RE: Federal T SWD No. 1 (API 30-015-26404) SWD-1135

RE: REQUEST BY HOLLYFRONTIER TO DENY LIME ROCK'S REQUEST TO INCREASE
INJECTION PRESSURES AT FEDERAL T SWD#1 (API # 30-015-26404)

RE: Injection Pressure Increase Request
Administrative Order SWD-1135
FEDERAL T SWD #1
API#: 30-015-26404
Unit Letter "A" Section 12 T18S R27E
Eddy County, New Mexico

Figure 1:

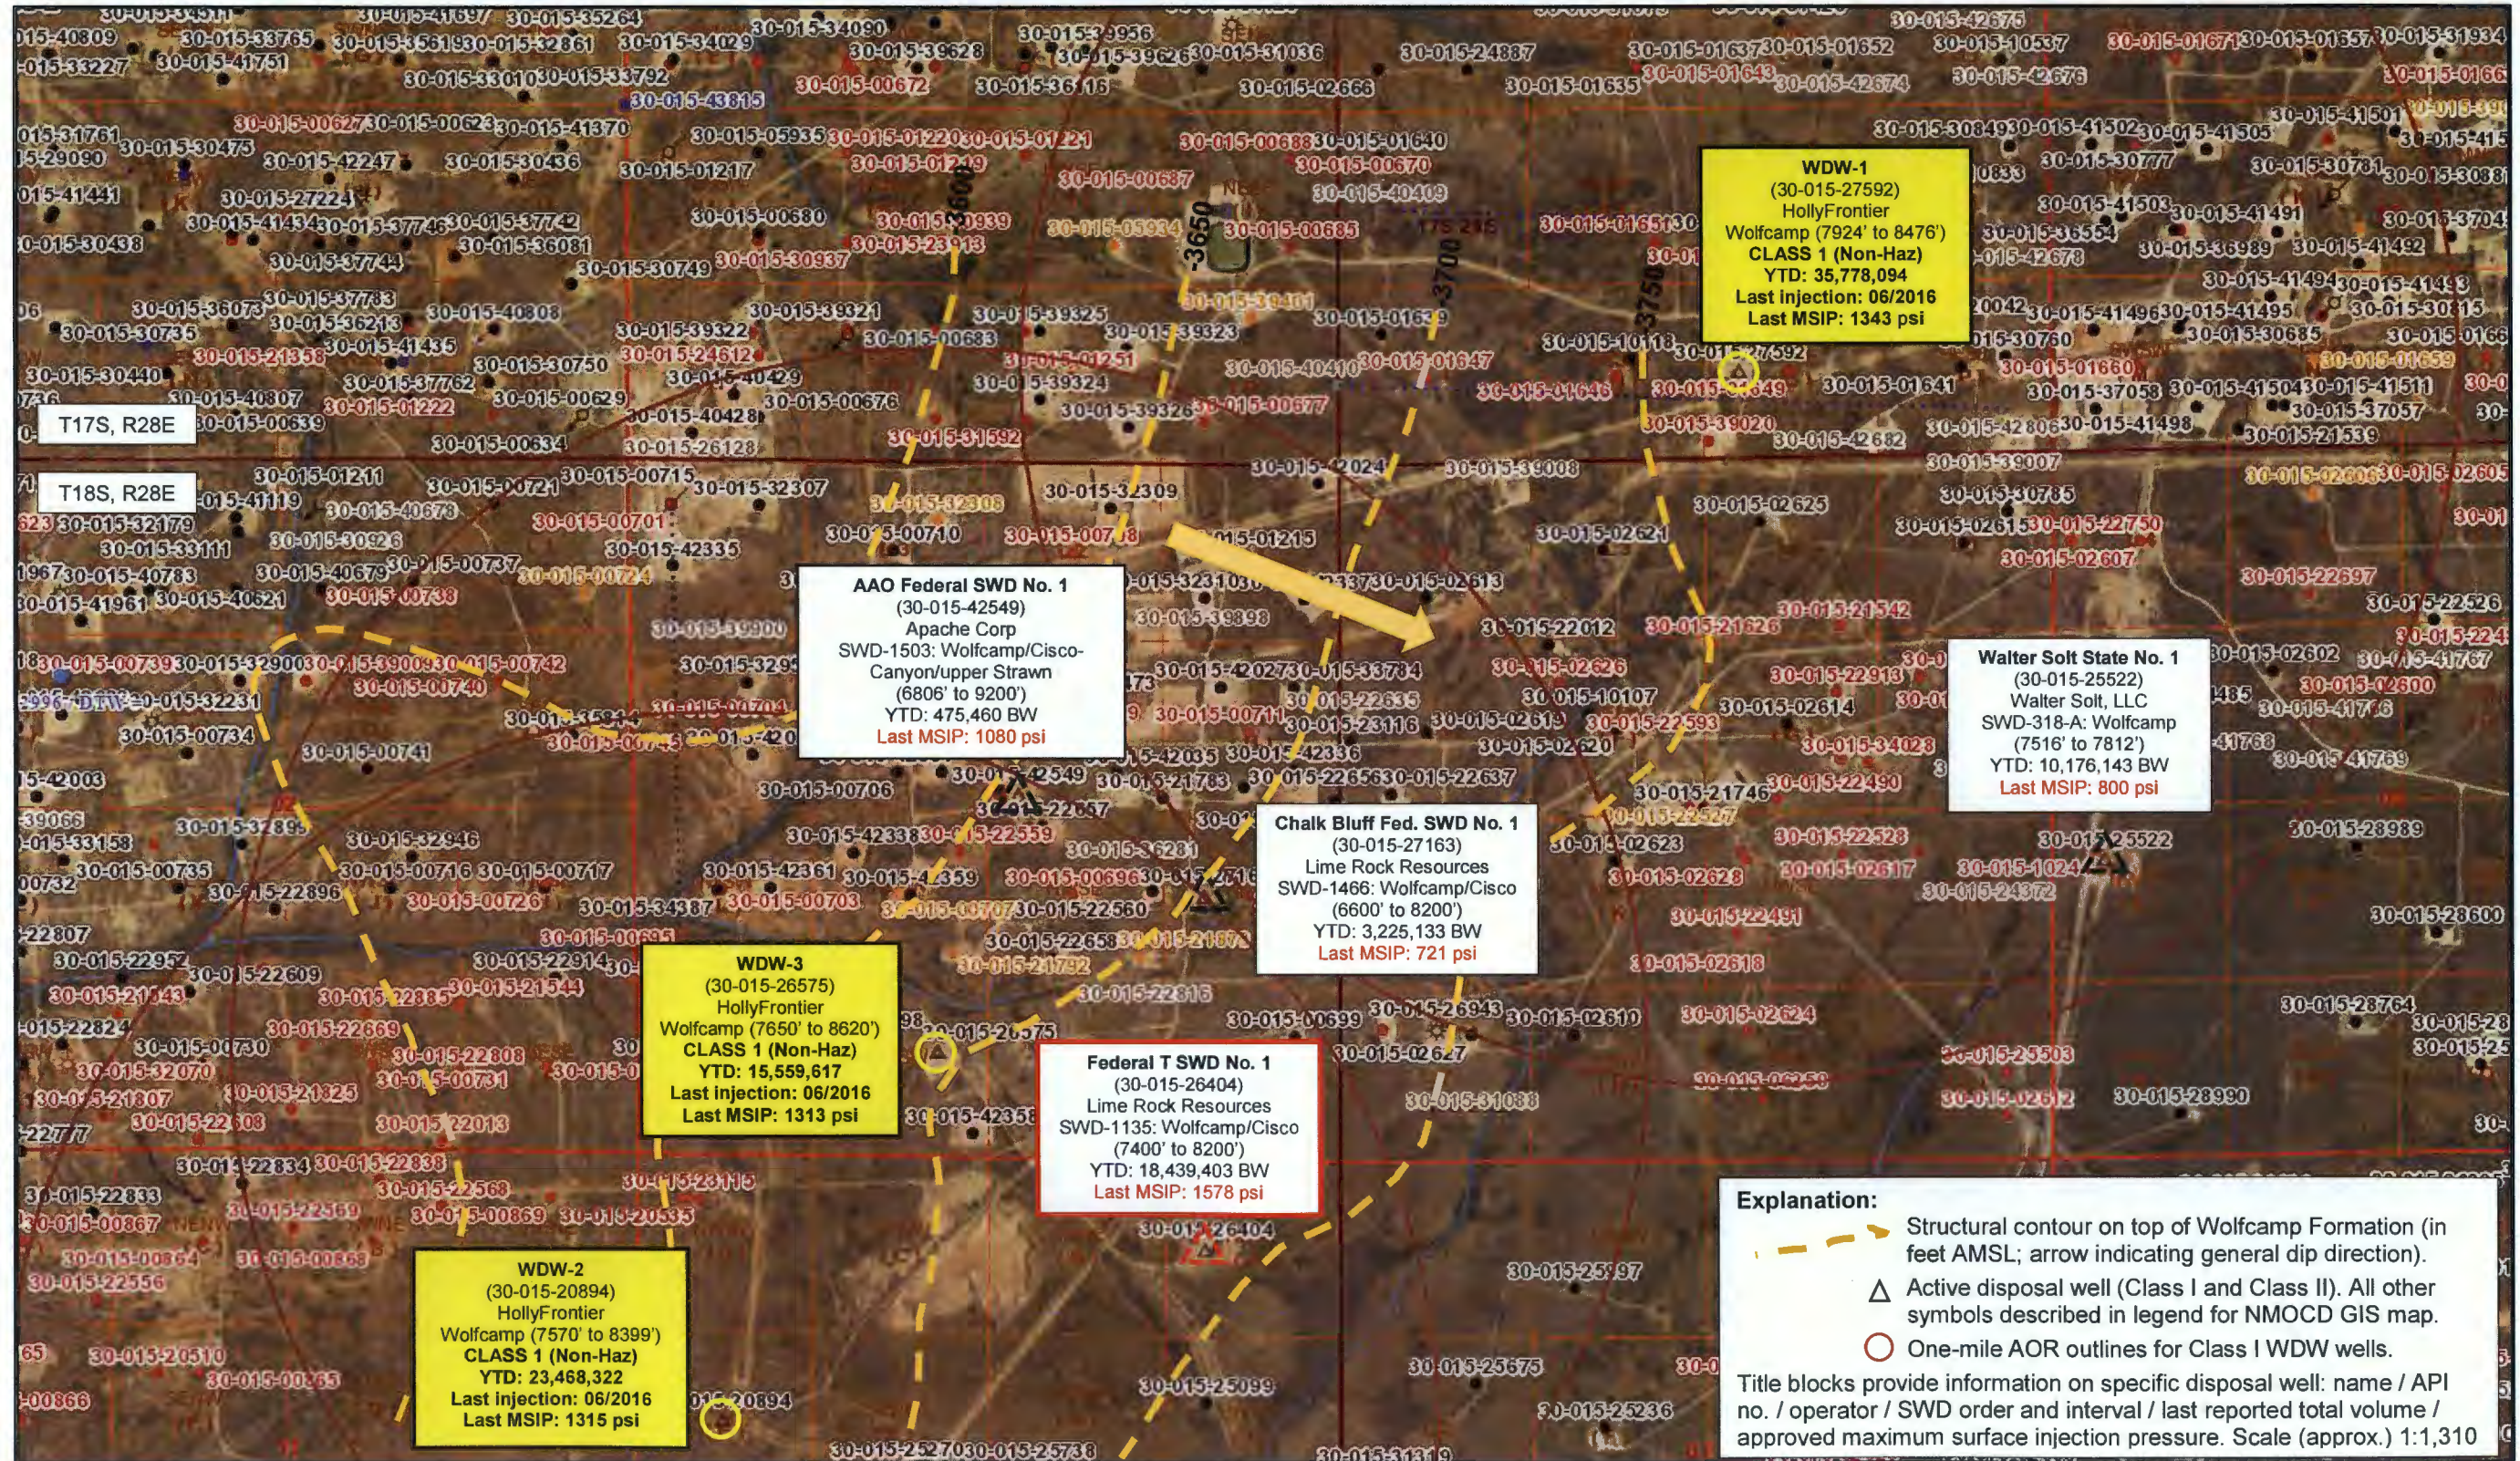
As seen in Figure 1, there are only approximately 2,500 feet separating HFNR's WDW-3 from Lime Rock's Federal T SWD #1, and both wells have completions in the same Cisco zone. The Federal T SWD #1 perforations in the Cisco Formation range from 7,685' to 8,060', and the WDW-3 Cisco perforations run from 7,666' to 8,620'. This overlap allows pressure fronts (and fluids) to migrate from the Lime Rock SWD to HFNR's WDW-3, potentially impairing the function of WDW-3.

Figure 2: Cross Section between WDW-3 and Federal T SWD #1

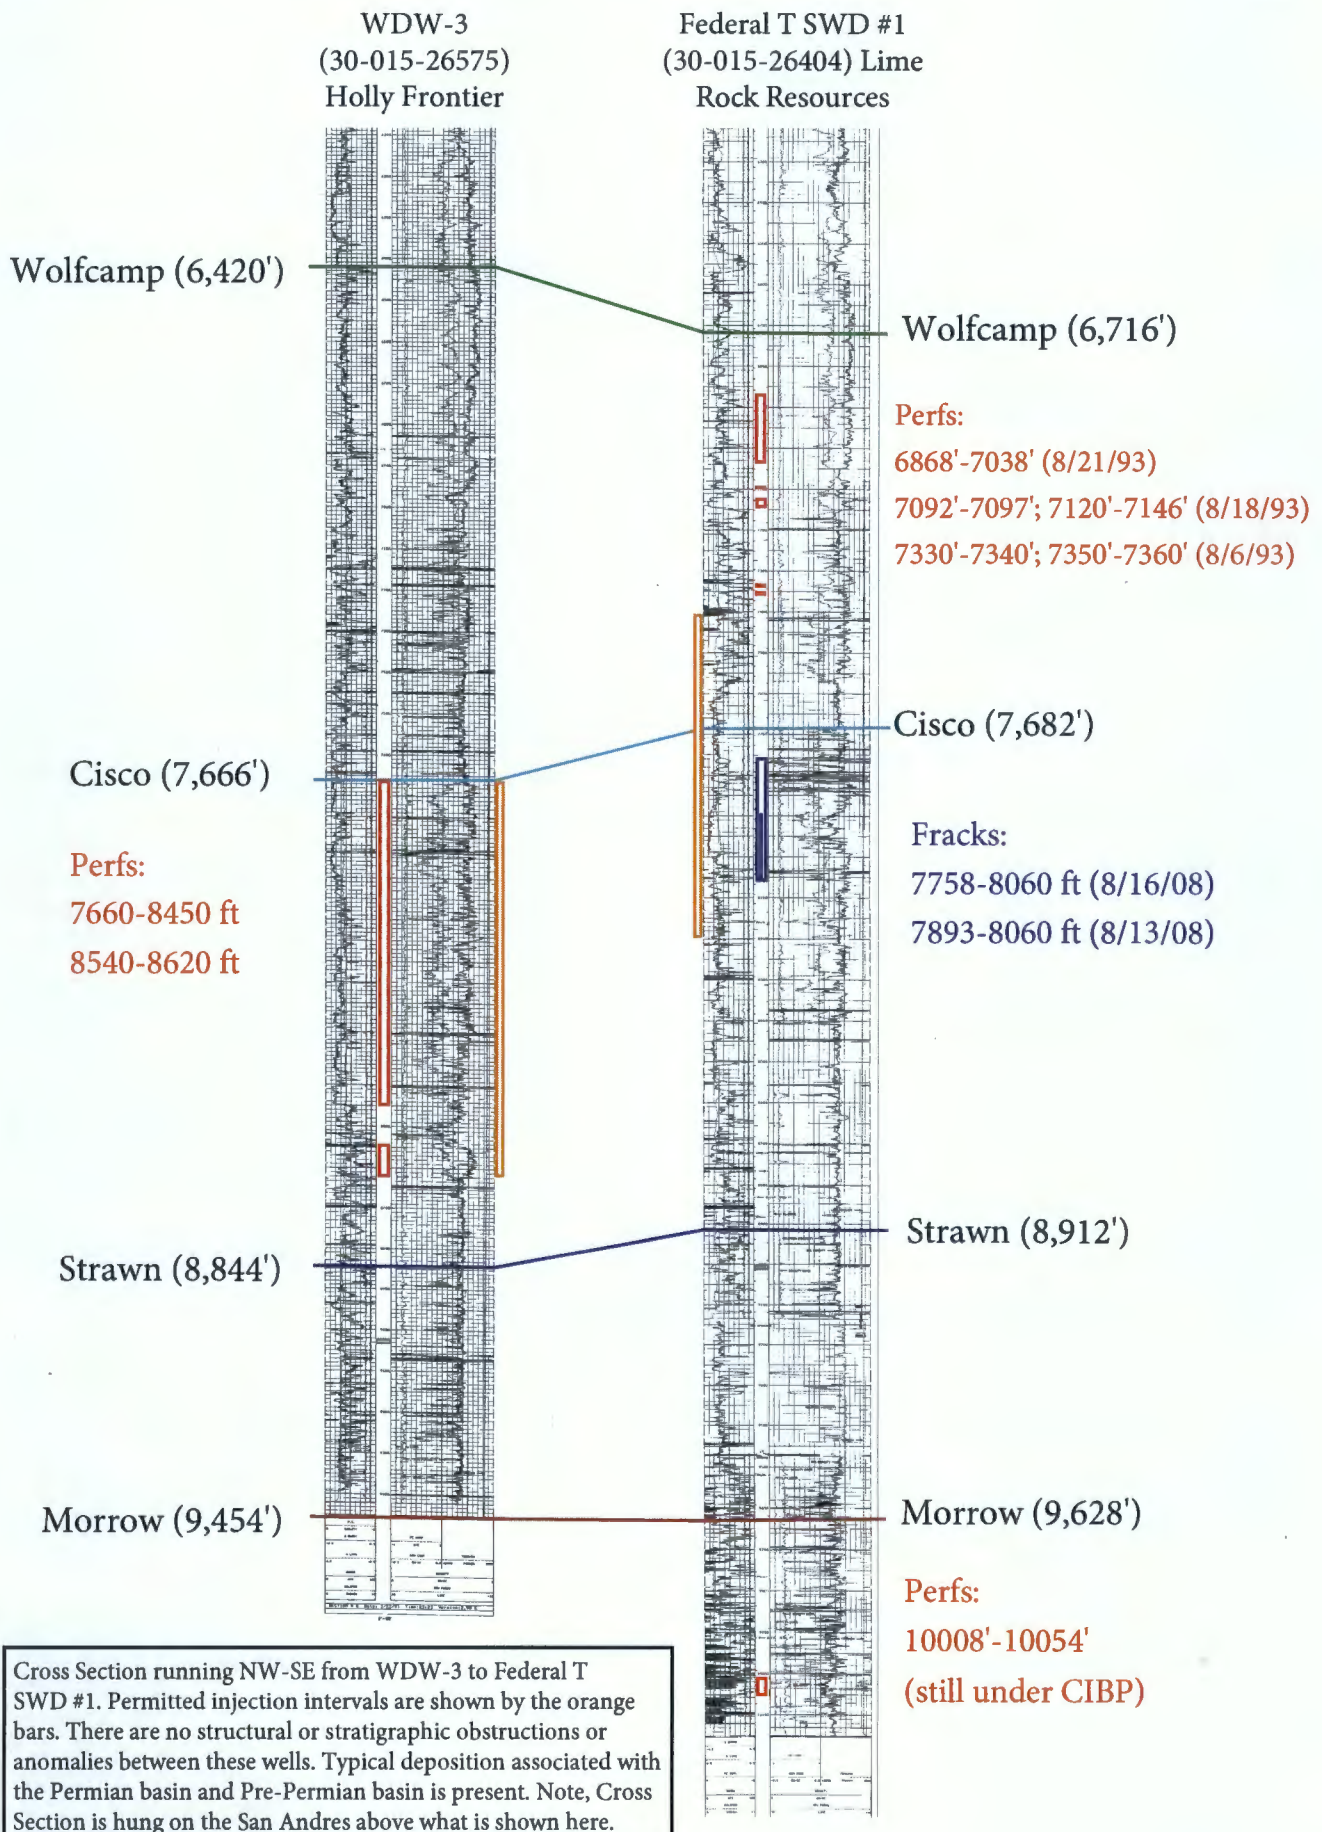
Figure 2 is a cross-section showing the geology of injection zones of WDW-3 and Federal T SWD#1. There is clearly an overlap of the injection zones in the Cisco Formation, the lithologies of the Cisco are very similar, and it is clear that there are no stratigraphic or structural barriers between the wells. This direct connection will ensure that increased injection pressure in the Federal T SWD #1 will result in the migration of a pressure wave to WDW-3 that will negatively affect HFNR's ability to stay within their approved MAOP of 1,550 psig surface.

Cross Section running NW-SE from WDW-3 to Federal T SWD #1. Permitted injection intervals are shown by the orange bars. There are no structural or stratigraphic obstructions or anomalies between these wells. Typical deposition associated with the Permian basin and Pre-Permian basin is present. Note, Cross Section is hung on the San Andres above what is shown here.

WELL COMPLETION DIAGRAM PROVIDED IN LIME ROCK'S REQUEST
FOR PRESSURE INCREASE SHOWING ZONES OF HYDROFRACTURING
IN FEDERAL T SWD#1

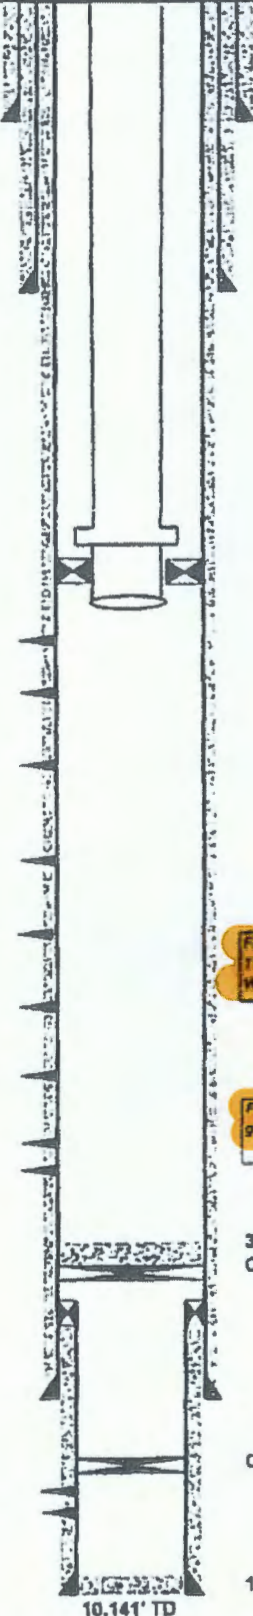
These fracture jobs are also noted in the well diagram submitted as part of Lime Rock's May 2017 pressure increase application (see Attachment B).

It is clear that the reason that Lime Rock observed that "The formation pressure did not break at a maximum surface pressure of 2681 psi (bottom hole pressure of 4140 psi)..." during their SRT is that the formation had already been broken during the hydrofracturing work done in 2008. For these reasons the step rate test results and conclusions are invalid and cannot form a defensible technical basis for Lime Rock's IPI request.
